Technical Bulletin C542

Product: DVD Player

Hardware Technical Bulletin:C542-H2005-03

Subject: Laser ribbon cable

Figure 1

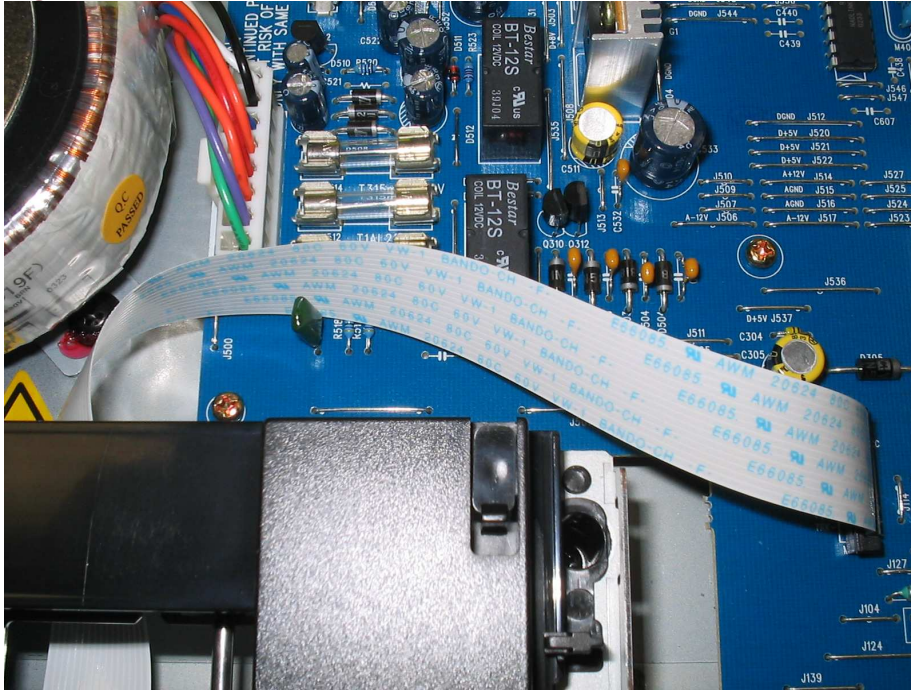
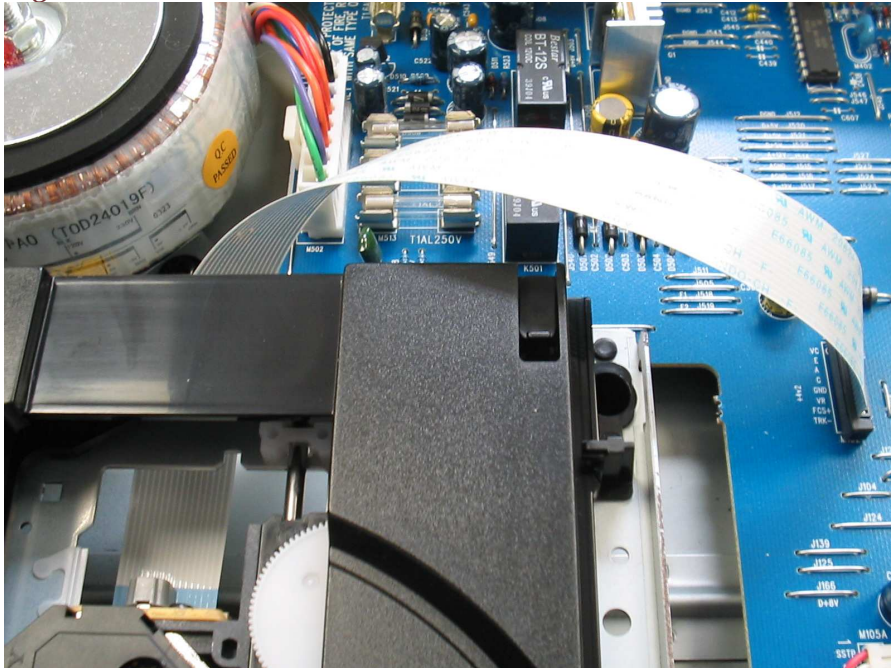
DESCRIPTION: You may have the complaint that some tracks skip or stops playing altogether.

REASON: The laser pick up connects to the main pc board via a flat ribbon cable and is possibly twisted the wrong way . It maybe getting caught on the fuse holders or other parts. just behind the transport mechanism . See figure 1.

SOLUTION: The ribbon cable needs to be allowed to wrap smoothly as shown in figure 2.
